**MAINE DEPARTMENT OF
INLAND FISHERIES AND WILDLIFE**

**ADDENDUM NO. 4
29-AUG-23**

**IMPROVEMENTS AT GRAND LAKE STREAM STATE FISH HATCHERY
GRAND LAKE STREAM, MAINE**

BGS PROJECT NO.: 3289-14

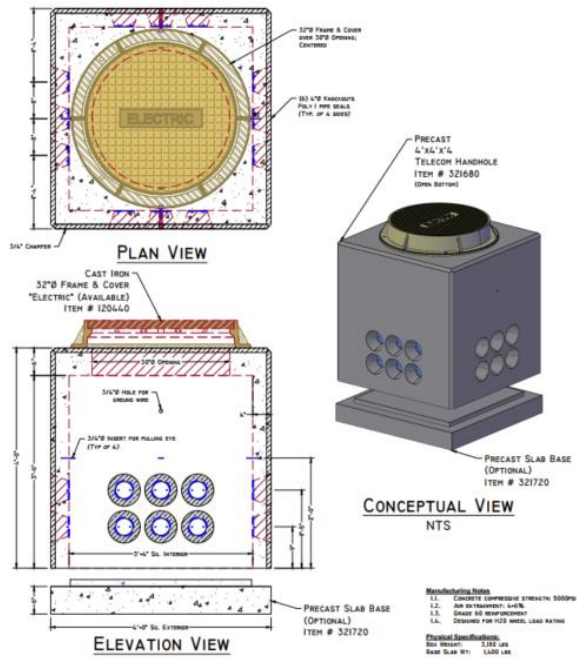
- QUESTION:** The Effluent building is to be kept just above freezing, while the pavilions are unheated, yet they are listed as having the same Roof Snow Load. This should not be the case, since they are designed for different heating conditions. Please clarify.

ANSWER: Sheet 00S-100 has incorrect values for the Thermal Factor and Flat Roof Snow Load for the Effluent Building. The Thermal Factor for the Effluent Building should be 1.1 and the Flat Roof Snow Load should be 61.6 psf.
